MEMORANDUM

From: Andrea Connell, RSP1
John Canning, P.E.
Village of Monroe Traffic Consultant

Subject: Proposed Warehouse - Craigville Logistics
Craigville Road, Town of Blooming Grove, NY
Review of accepted DEIS

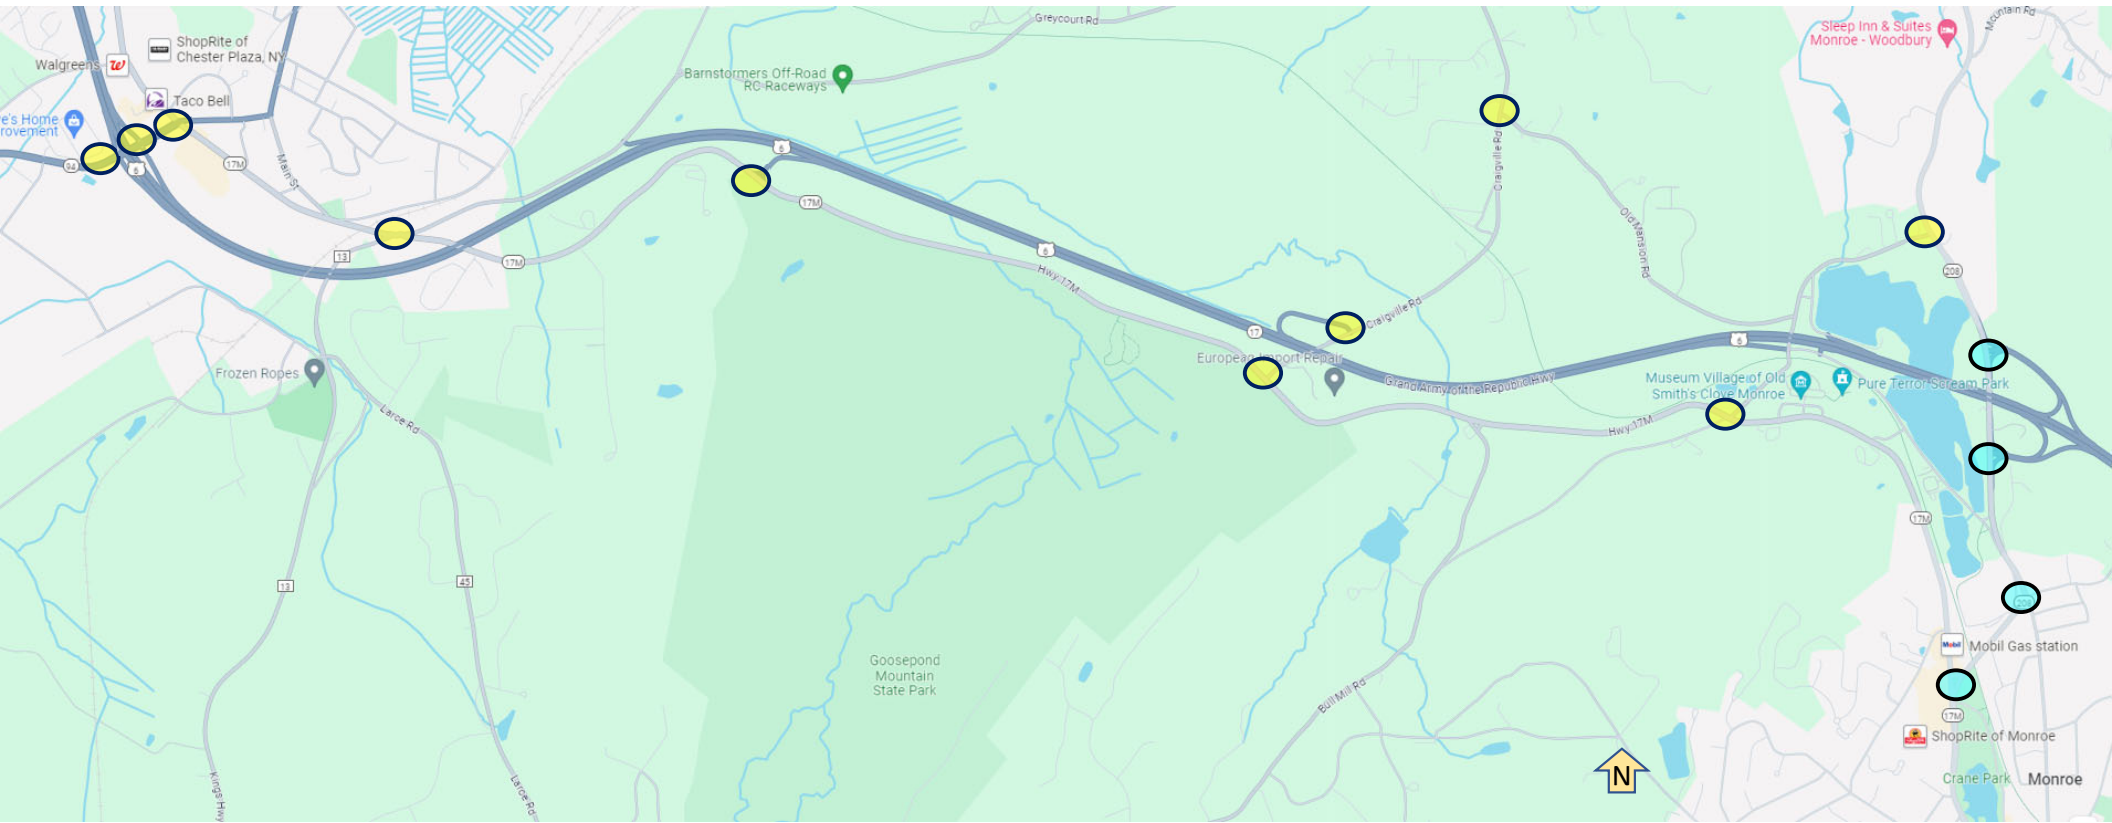
The TIS provides quantitative analyses (detailed intersection capacity analysis) for existing and future traffic operating conditions at 10 intersections, none of which are in the Village of Monroe. A qualitative analysis (identifying the number of Project trips at an intersection) has been provided at a further 4 intersections (2 in the Village). The TIS evaluated the weekday AM and PM peak hours and the Saturday peak hour. The study intersections are listed below (and shown on the attached Figure).

The Project trips were assigned to the study intersections based on the trip distribution percentages. The TIS (Figure 1 in Attachment F, copy appended herewith) shows the amount of truck and passenger car trips at 8 intersections, including the two intersections in the Village of Monroe. Per the Figure, it is estimated that up to 8 passenger car trips will travel through the NYS 17M intersection with NYS Route 208 and up to 4 passenger car trips will travel through the NYS Route 208 intersection with N. Main Street and Schunnemunk Road. No truck trips are projected to travel through either of these intersections.

Although the Route 208/N. Main Street intersection currently experiences significant delays, it is not anticipated that the warehouse will have a significant adverse impact at the intersection during the peak hours due to the low volume of traffic added (4 vehicles). Similarly, the 8 additional trips added to the Route 17M intersection with Route 208 is not expected to result in noticeable increases in delay. However, as discussed above, if the warehouse were to be used as a higher-generating facility, then

If the Applicant does not confirm that the proposed buildings will not be used as a High-Cube Fulfillment Center (Sort) Warehouse or a High-Cube Parcel Hub Warehouse, it is suggested that the Board request that the Applicant provide standard intersection capacity analyses for the intersections of NYS 17M with NYS 208, Lake Street and Stage Road.

It is suggested that the Board ask the Applicant to provide a justification for not performing an analysis of the three Route 17M intersections listed above during these busy periods on I-87 and NYS 17.
